# Central Community College – Kearney Center

## Addendum 2

Wilkins Architecture Design Planning  
2908 West 39<sup>th</sup> Street, Suite A  
Kearney, Nebraska 68845  
308-237-5787

Date Issued: February 18, 2016  
Bid Date: February 23, 2016

**1 DETAILS - DONOR WALL**  
 ASK-14 SCALE: 1 1/2" = 1'-0"

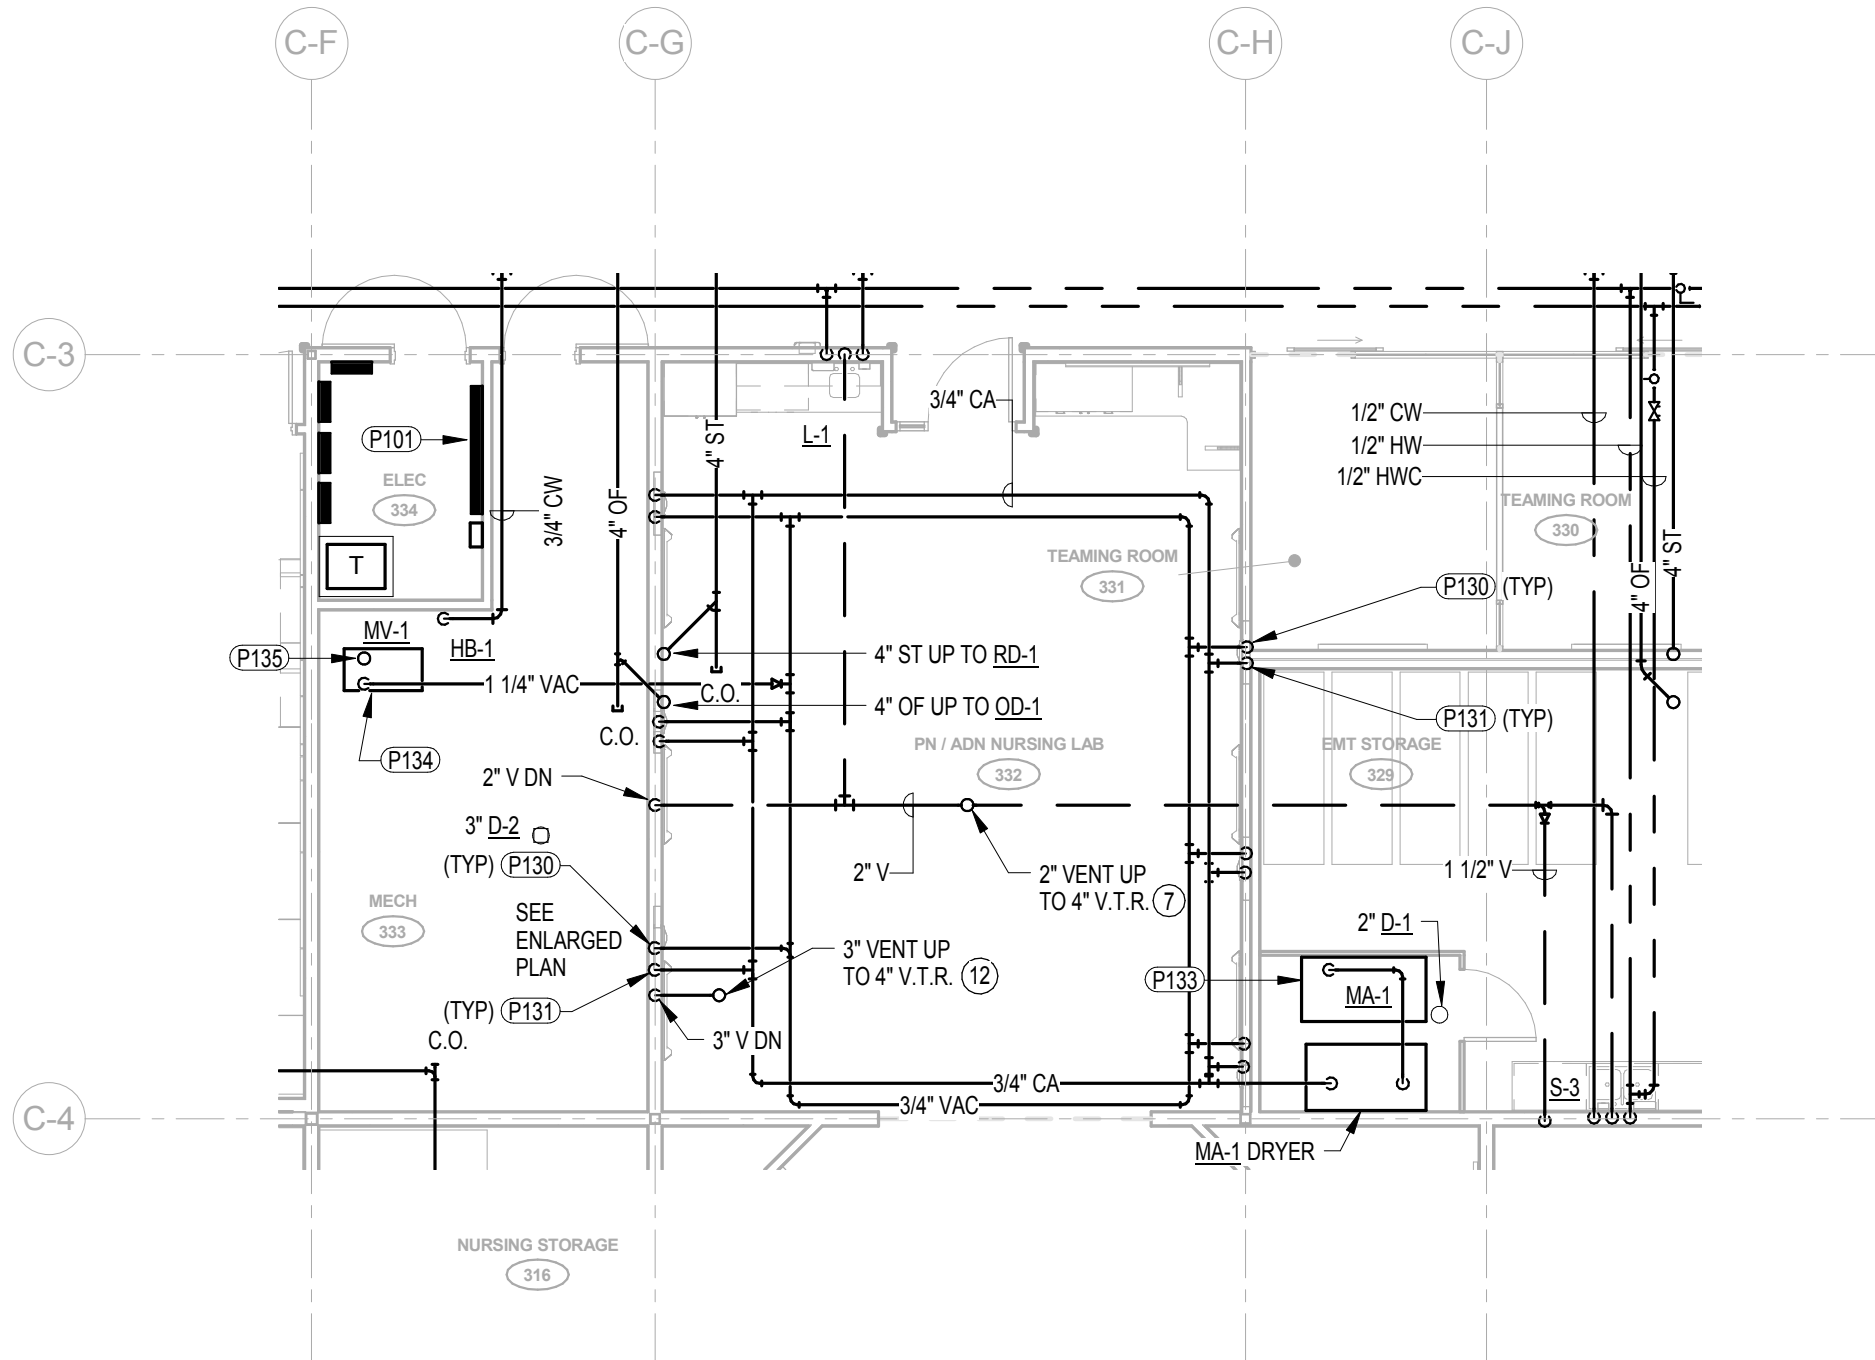
- Addendum 2 –57**     **Sheet A10.2 Casework Sections and Details**  
At 5/A10.2 DETAILS – DONOR WALL, replace detail with sketch ASK-14
- Addendum 2 –58**     **Sheet S2.2 Foundation Plan-Area B**  
Step CF-4 continuous footing on grid E-2 to allow for drain pipe. Refer to 1/SK-1 for top of footing elevations. Coordinate location of pipe with mechanical

Addendum No. 2  
PLUMBING PLAN - AREA C  
Sheet Ref: P2.3  
Sketch Date: 2/18/16

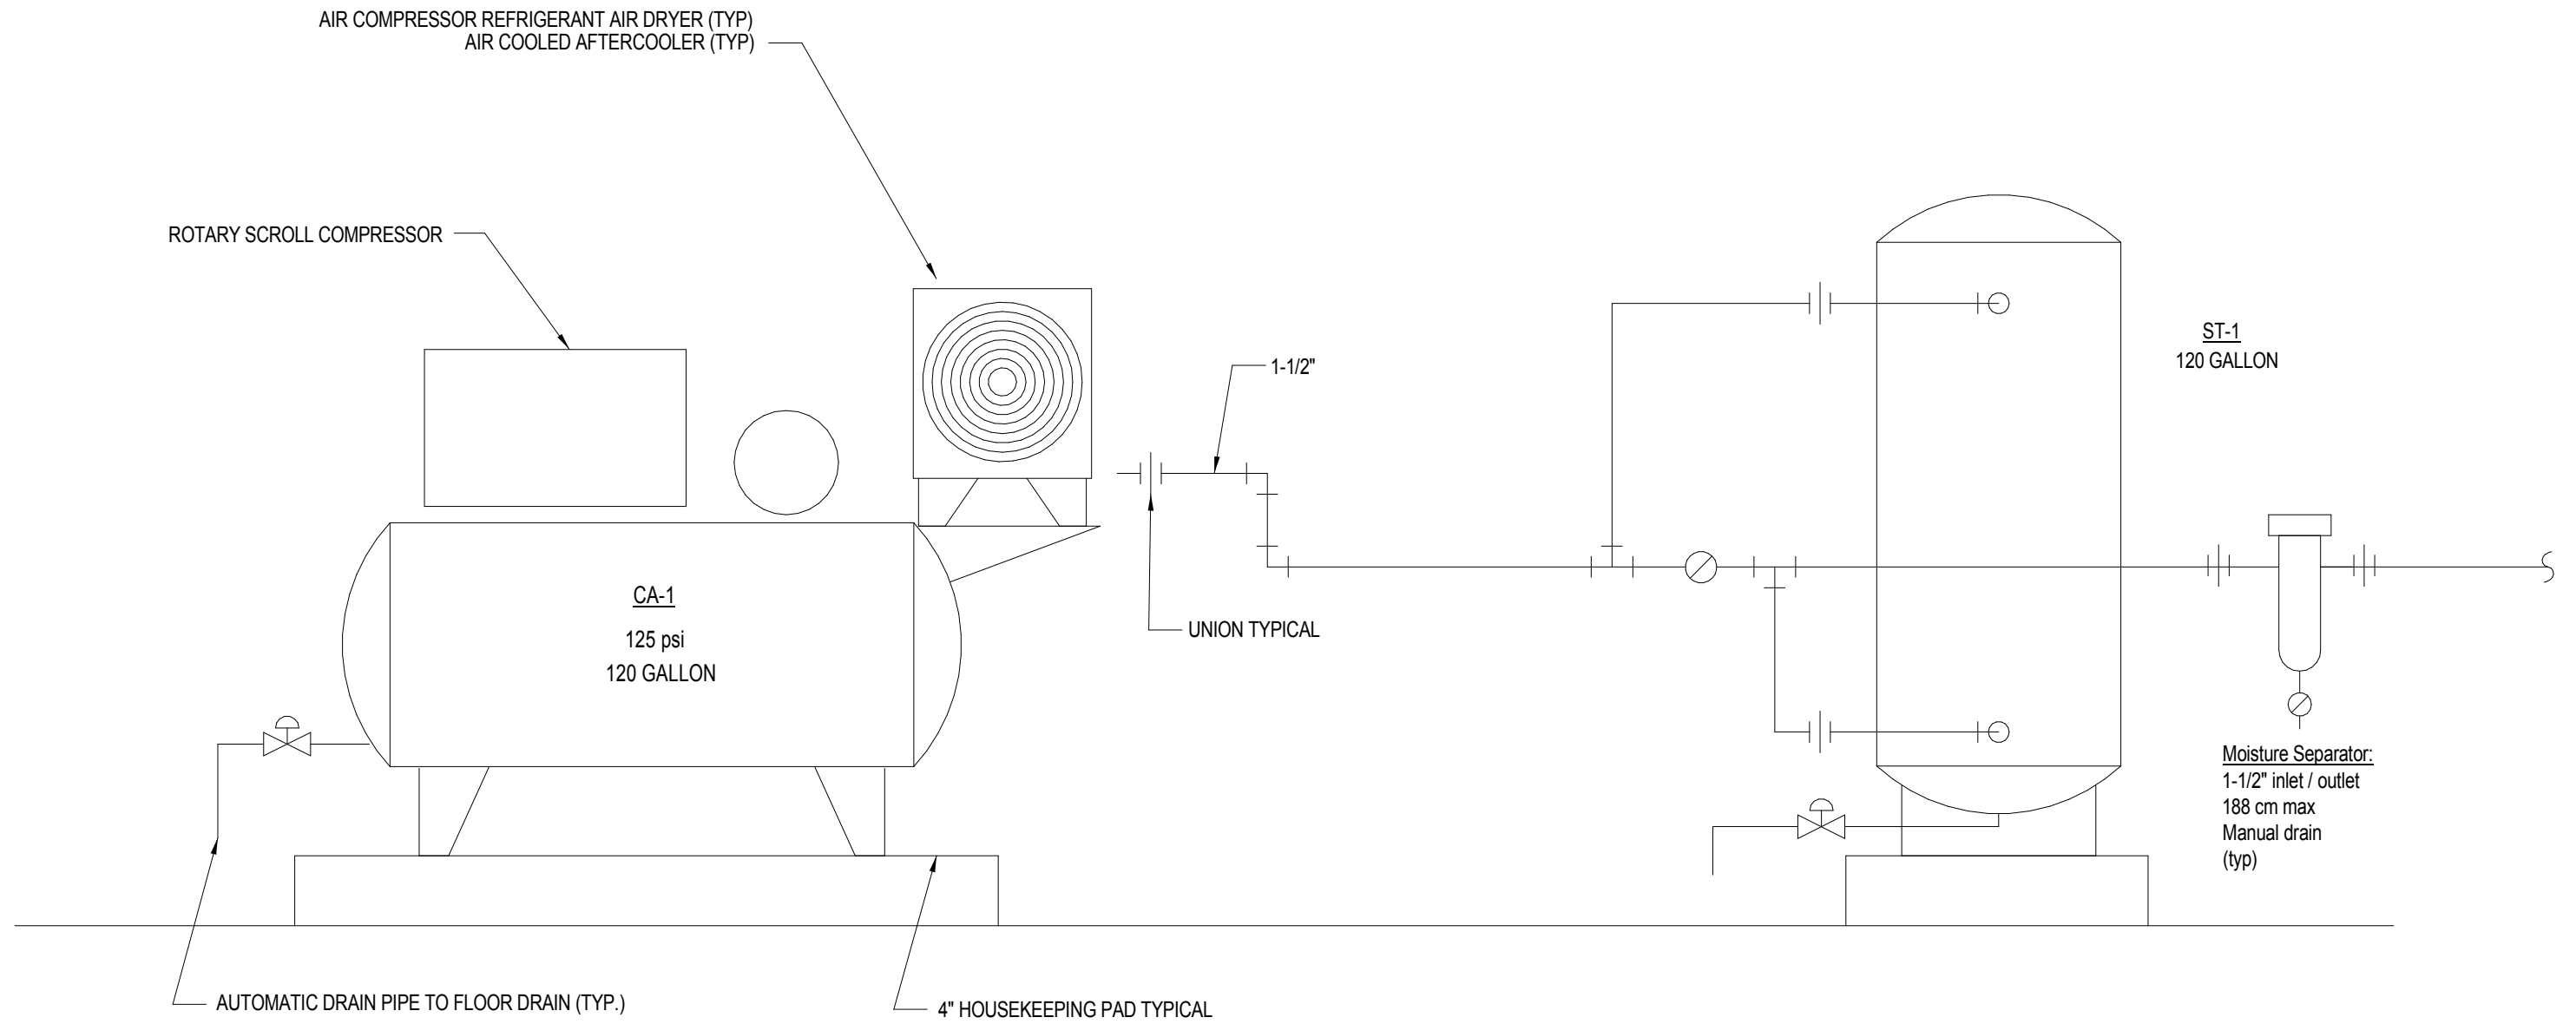
- See sketches PSK-02 and PSK-03 for revised MV-1 and MA-1 piping layout, and additional floor drain (2” D-1) in EMT Storage 329
- See sketch PSK-05 for revised downspout nozzle types, and revised note P122.

P122 OFFSET OVERFLOW PIPING TO EXTERIOR WALL. DROP PIPING DOWN TO DOWNSPOUT NOZZLE LOCATED ABOVE CORRIDOR CEILING. LOCATE NOZZLE AT APPROX. 11'-3" A.F.F.

5  
P5.2

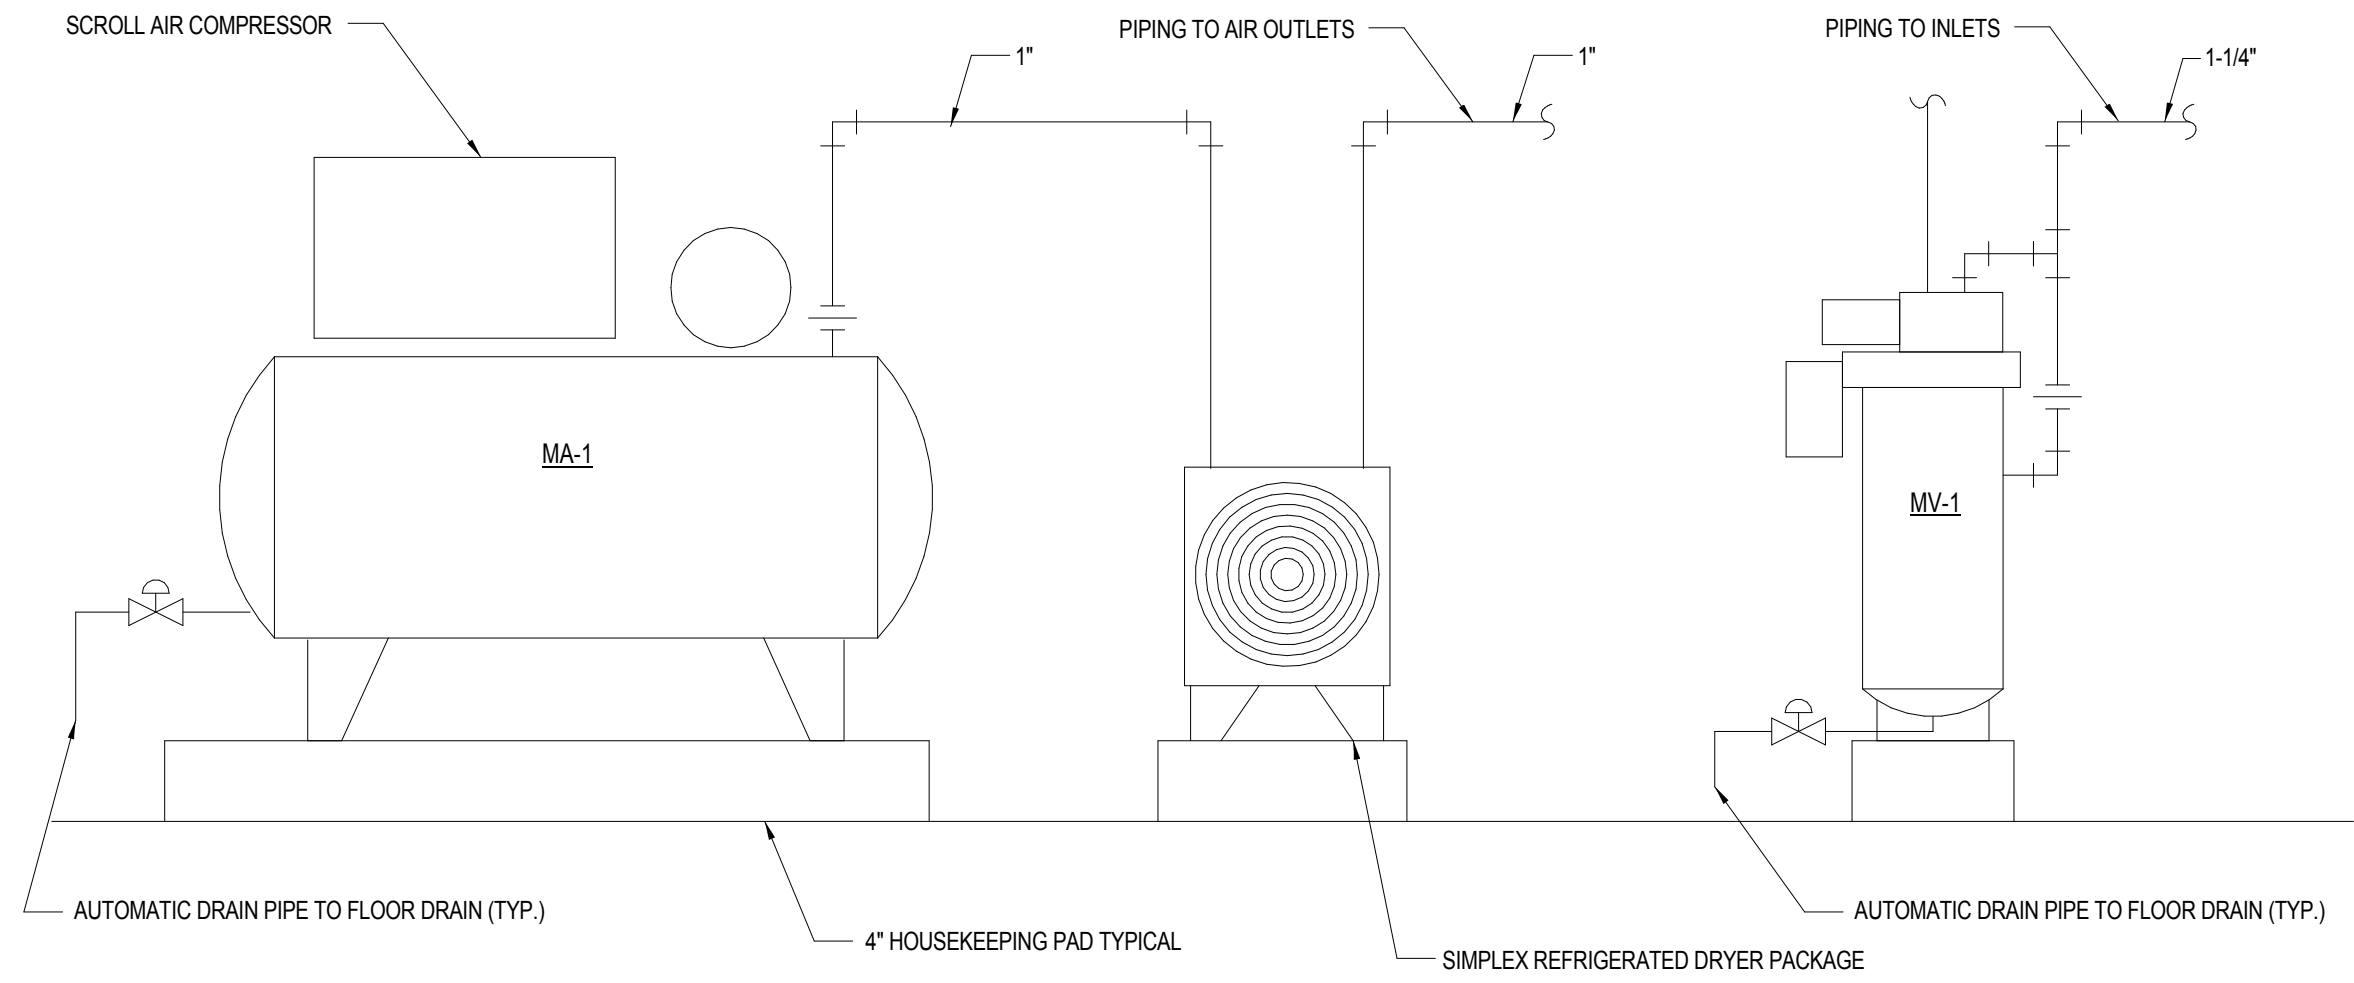
- Addendum 2 –69 Sheet P5.2- PLUMBING DETAILS**  
See PSK-06 for additional detail 5/P5.2, “COMPRESSED AIR SYSTEM DETAIL”, applicable to air compressor system located in MECH M102.  
See PSK-05 additional detail 6/P5.2, “MEDICAL AIR AND VACUUM SYSTEM DETAIL”, applicable to air and vacuum systems located in EMT STORAGE 329 and MECH 333..
